ADA Compliance Program

Clark County Facilities Transition Plan Clark County Elections and Auto License Building

1408 Franklin Street

Item: Detectable Warnings

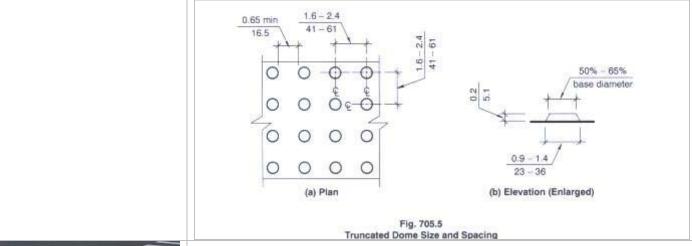
ANSI Code: 705.2 Standardization – Detectable warning surfaces shall be standard within a building, facility, site or complex of buildings

ANSI 705.5 Truncated Domes - Detectable warning surfaces shall have

ANSI 705.5 Truncated Domes – Detectable warning surfaces shall have truncated domes complying with Section 705.5 $\,$

Sides of ramp to crosswalk also should be flared.
